ADDENDUM NO. 2 TO PROJECT NO. 45011

**CONSTRUCTION WORK, HVAC WORK, PLUMBING WORK, ELECTRIC WORK
PROVIDE COMBINED SUPPORT MAINTENANCE SHOP
CAMP SMITH
11 BEAR MOUNTAIN BRIDGE ROAD
CORTLANDT, MANOR, NY 10567**

August 5, 2015

PLAN DETAIL - SW CORNER OF WORKBAY

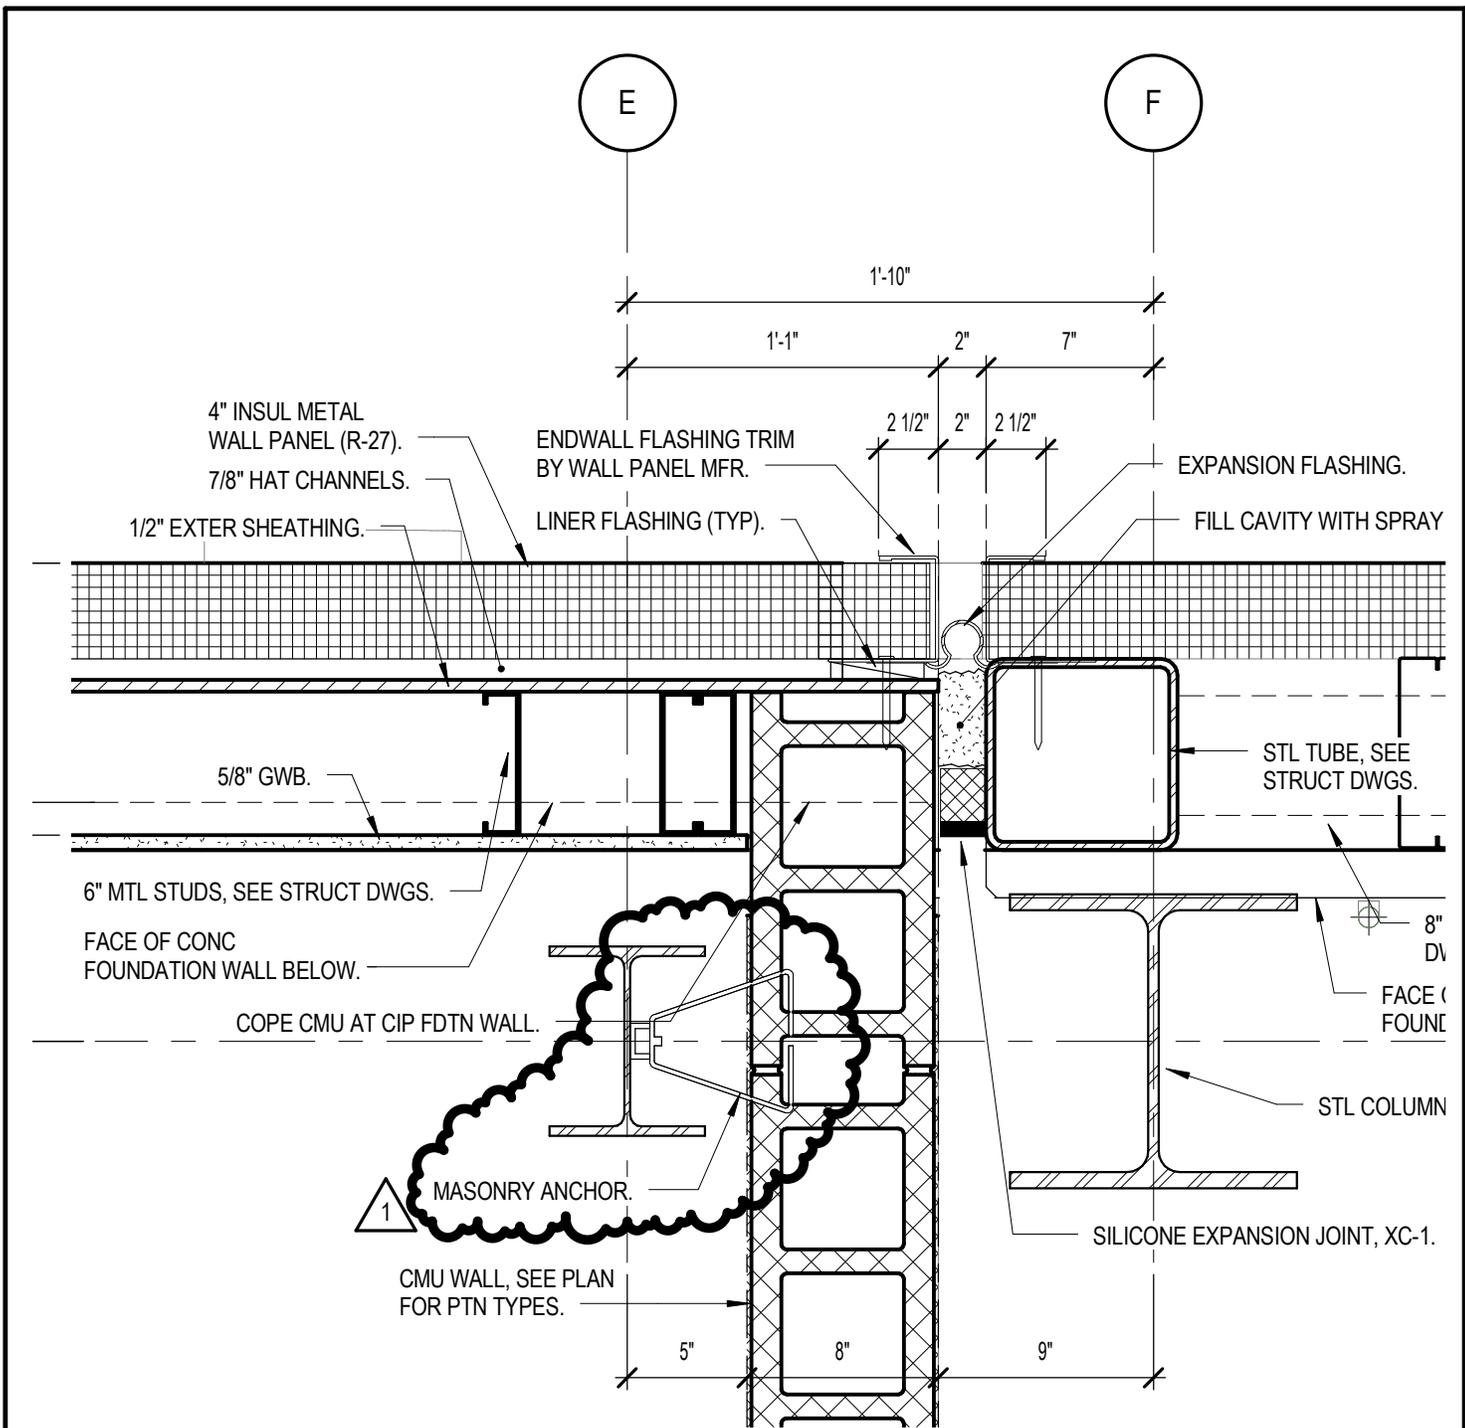
8. Drawing A-501
 - a. Detail B1, replace with JD-A7 Addendum Drawing dated August 3, 2015. Add adjustable masonry anchor at Column C.2/3.2.
 - b. Detail D5, replace with JD-A8 Addendum Drawing dated August 3, 2015. Add adjustable masonry anchor at Column 1/E.

SECTION - WINDOW SILL @ CAST STONE

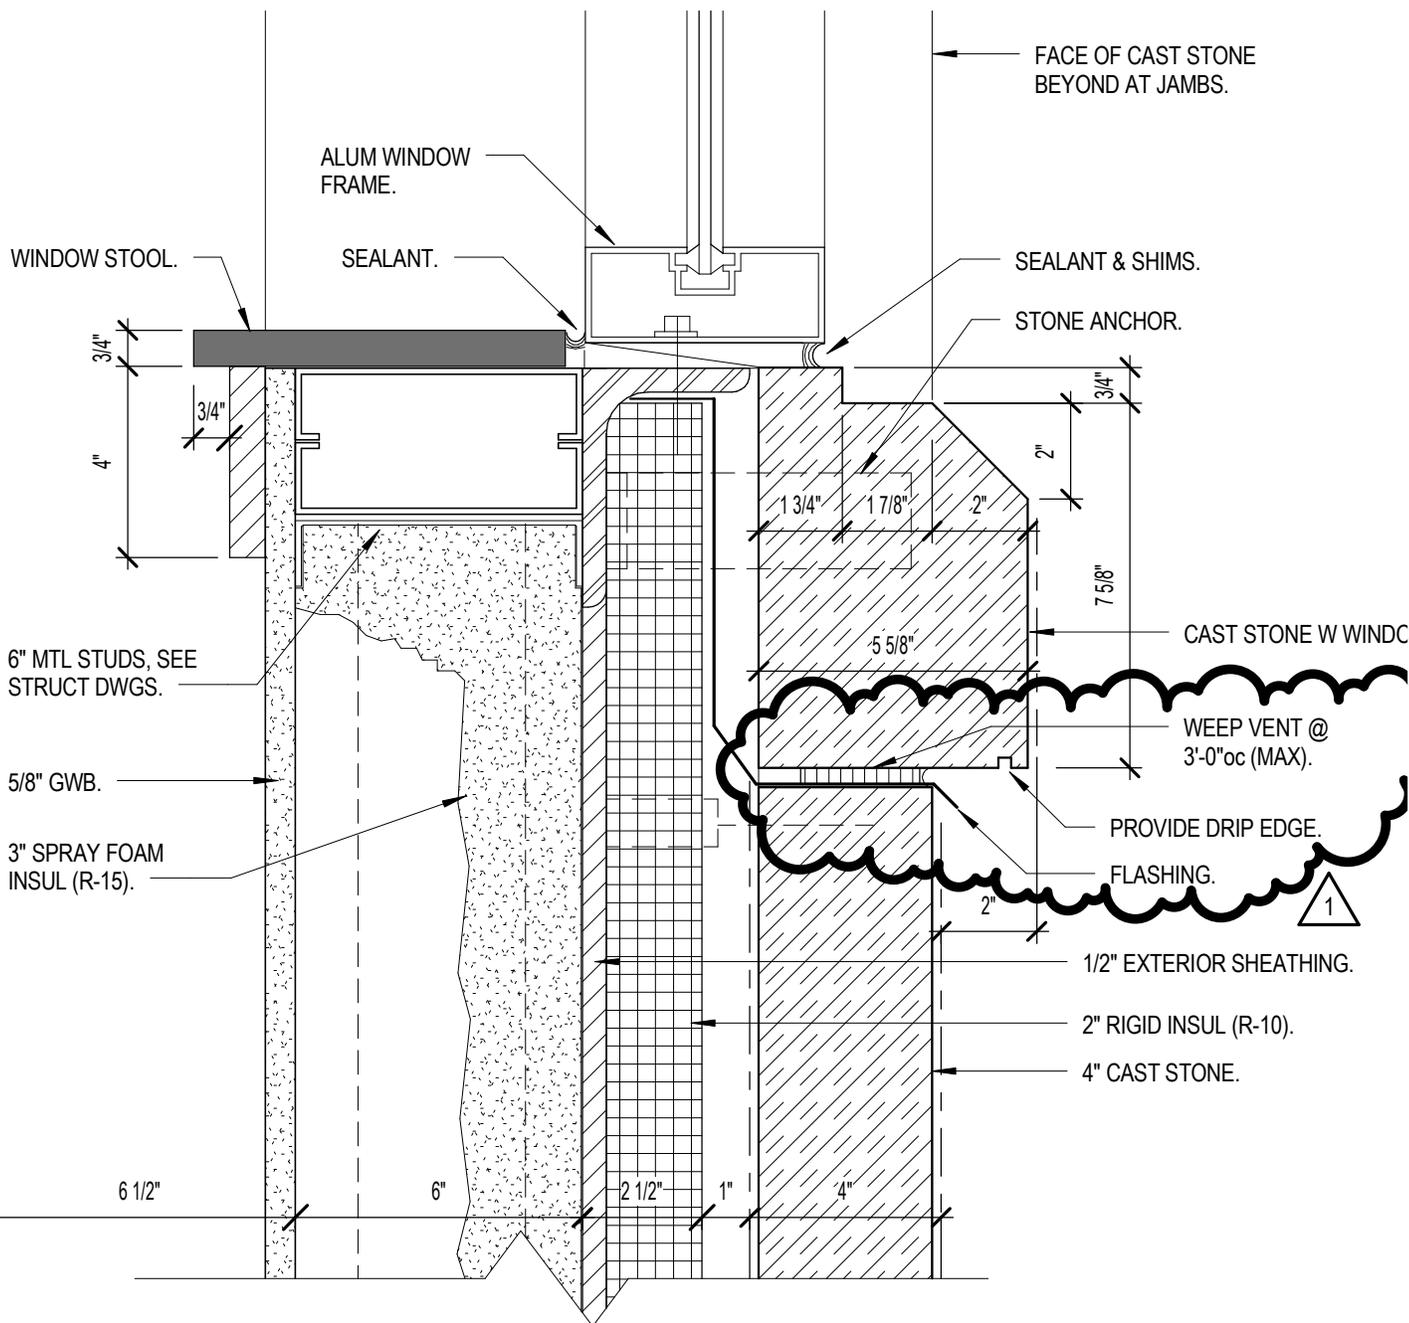
11. Drawing A-503
 - a. Detail A2, replace with JD-A9 Addendum Drawing dated August 3, 2015.
 - b. Detail A3, replace with JD-A10 Addendum Drawing dated August 3, 2015.

HEAD DETAIL AT TRANSLUCENT WALL PANEL

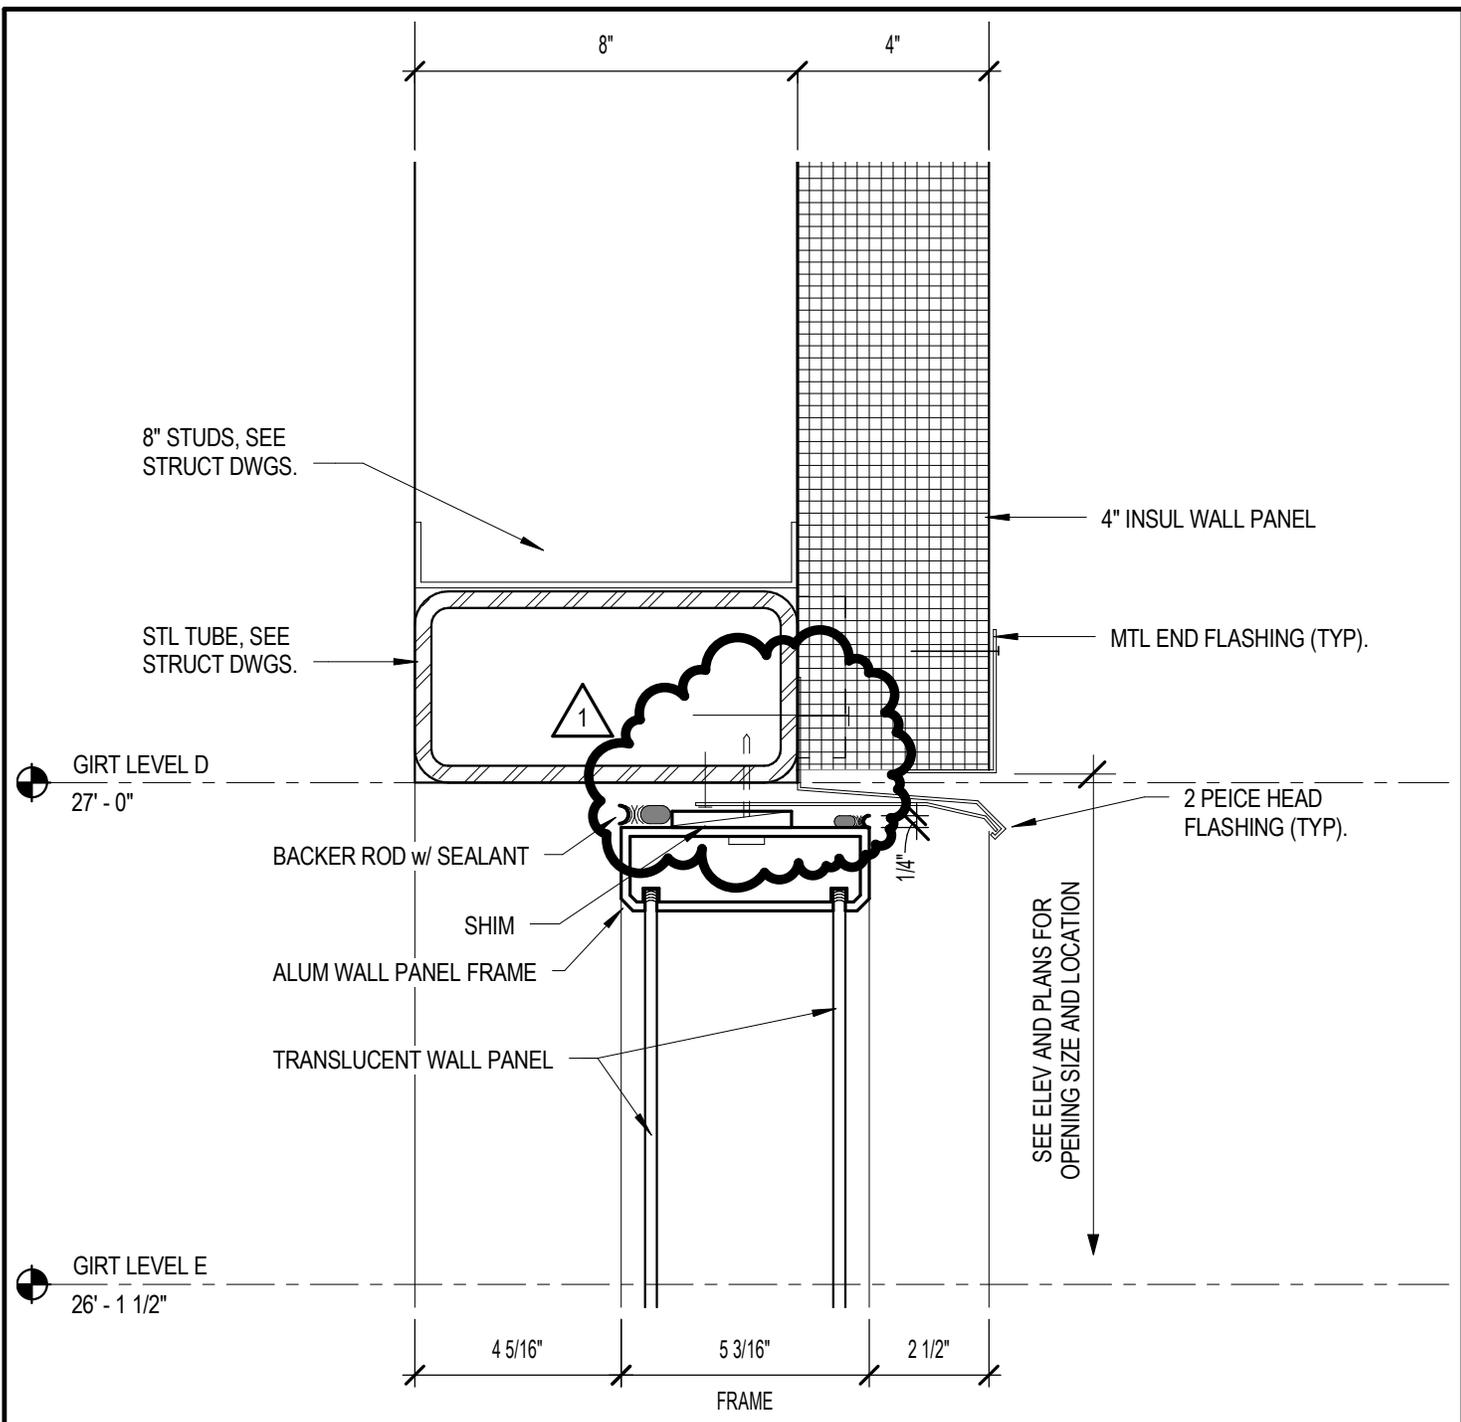
- c. Detail A5, replace with JD-A11 Addendum Drawing dated August 3, 2015.
 - d. Detail D2, replace with JD-A12 Addendum Drawing dated August 3, 2015.
12. Drawing A-551

SHEET TITLE
 REVISED SANITARY CALLOUTS
 REFERENCE SHEET C-401

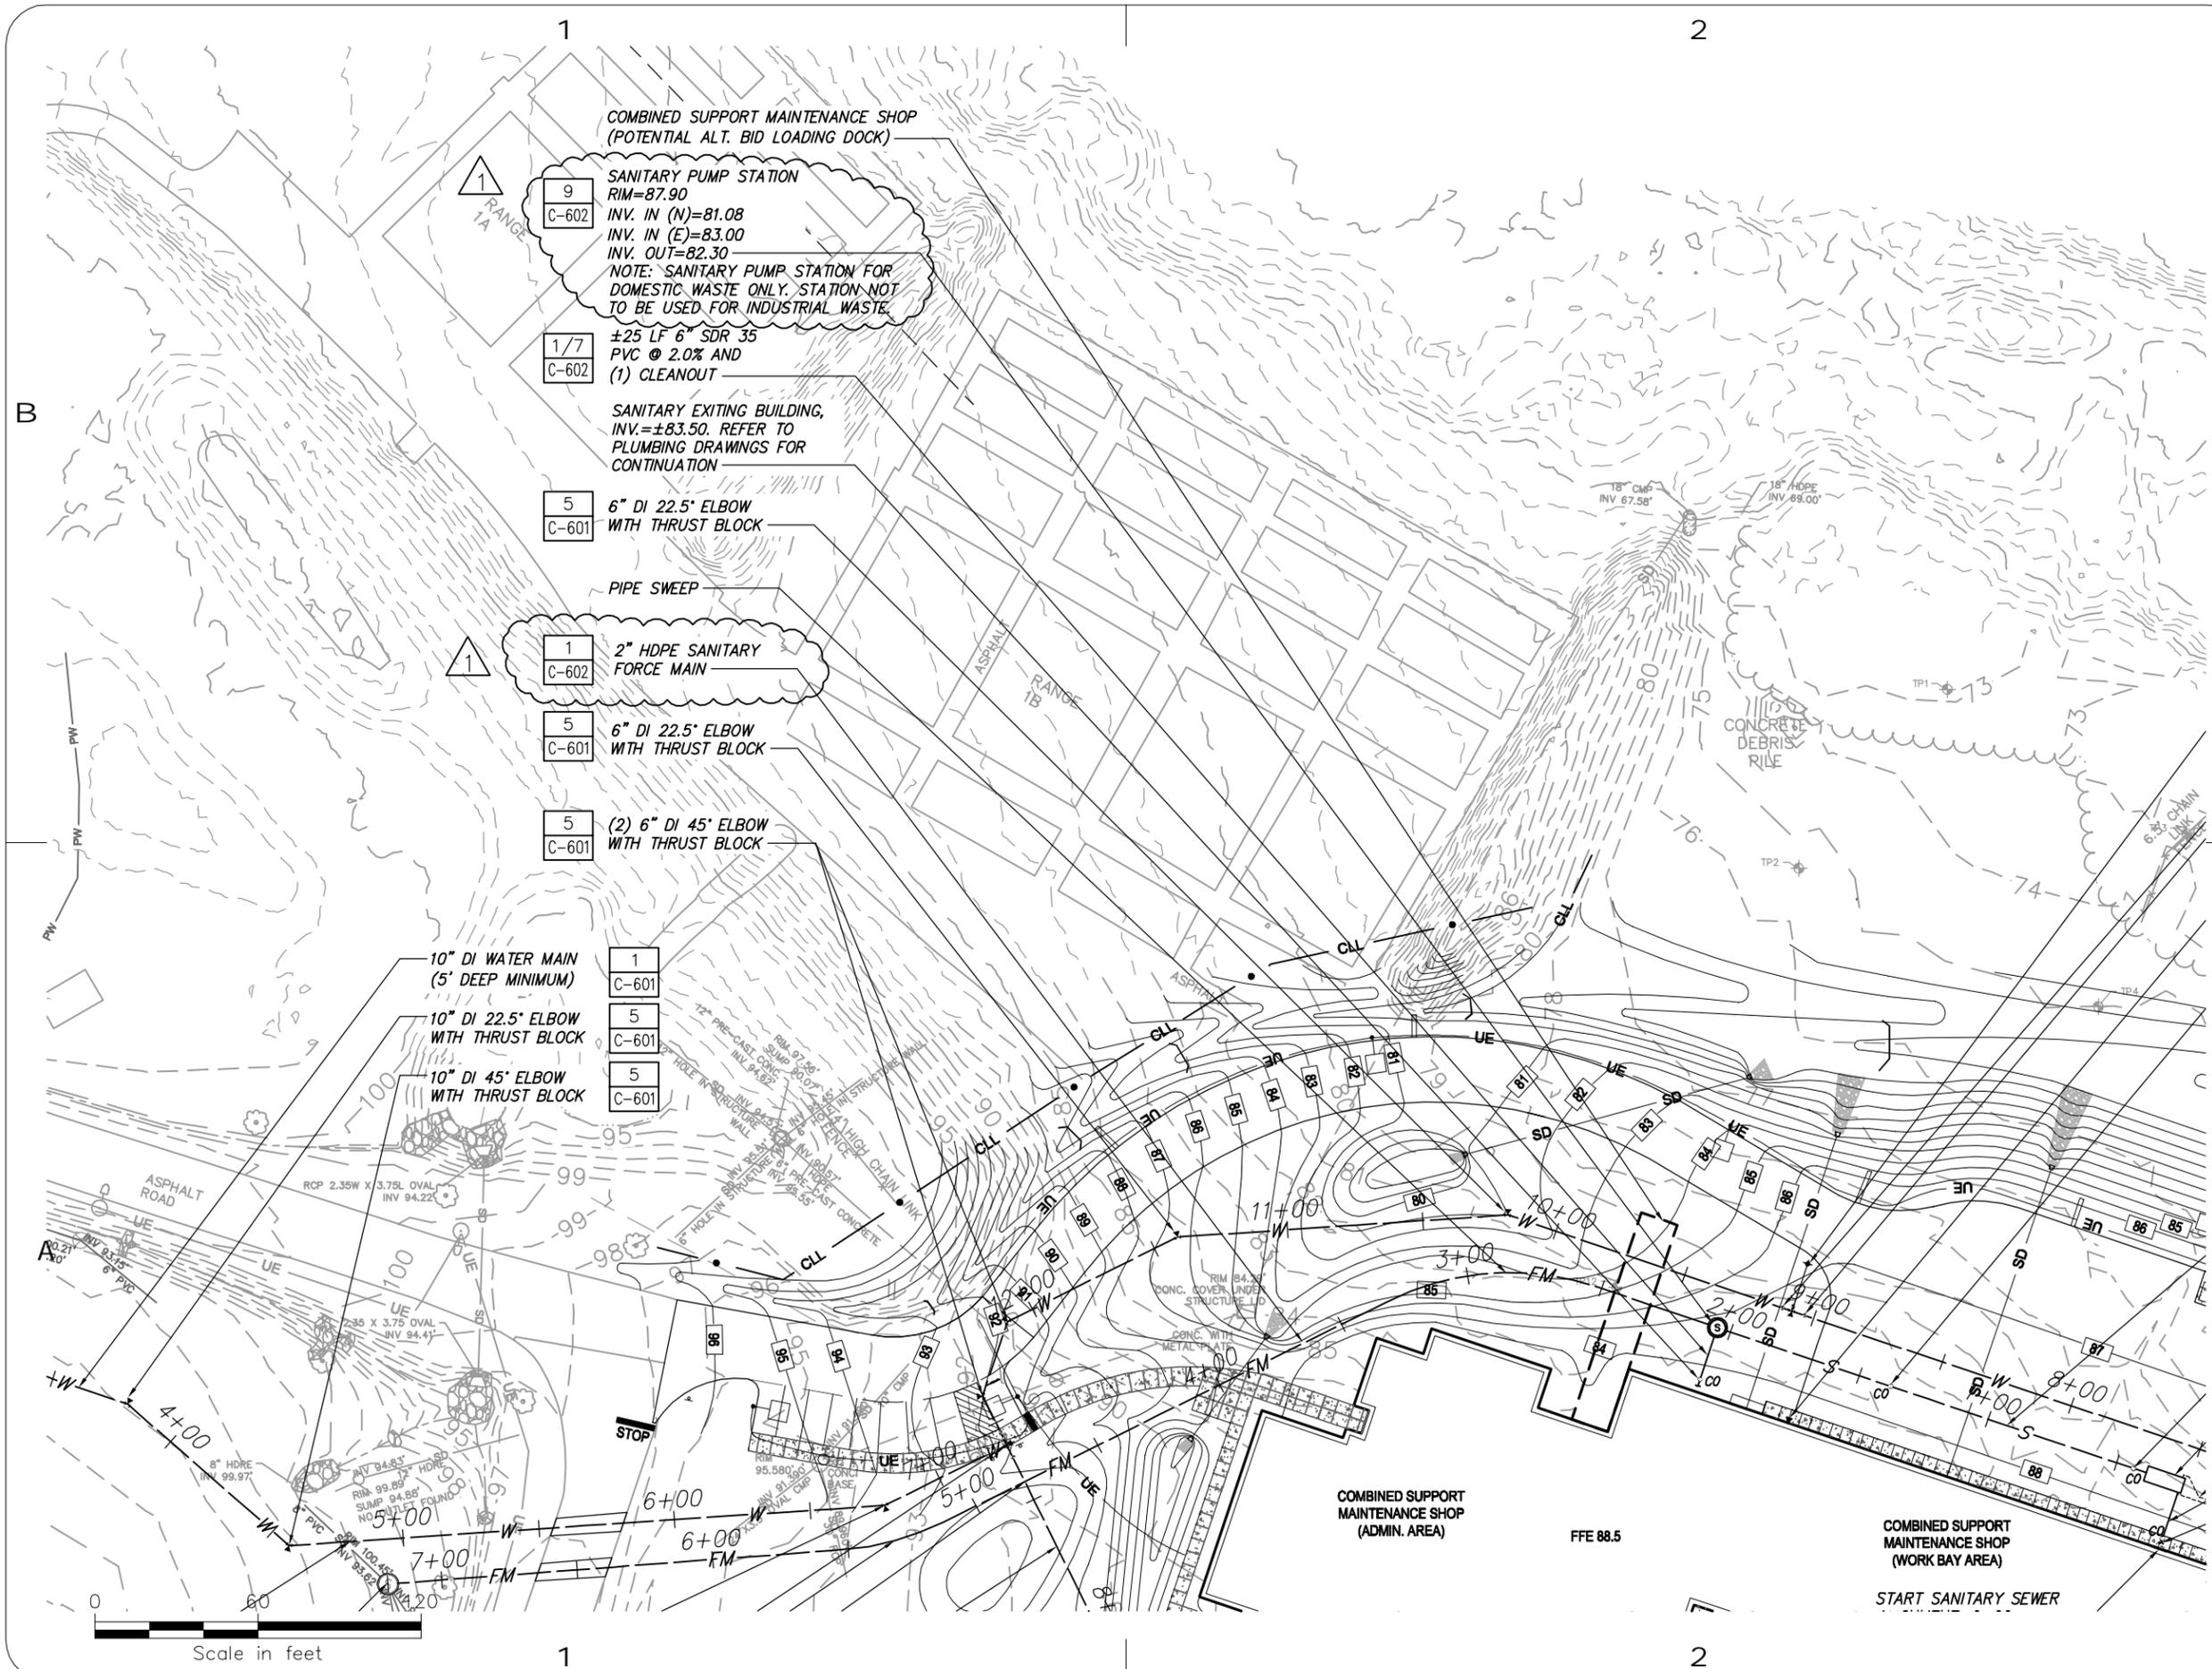
- a. Detail A4, Revise vertical dimension at stair riser to read, “7” MAX”.
13. Drawing No. C-401
 - a. Change note to state sanitary station for domestic use only, not for industrial waste. See SKC-001 Addendum Drawing dated August 4, 2015.

- b. Identified material of forcemain as HDPE in callout. See SKC-001 Addendum Drawing dated August 4, 2015.
 - c. Revised Oil/Water Separator configuration and callouts. See SKC-002 Addendum Drawing dated August 4, 2015.
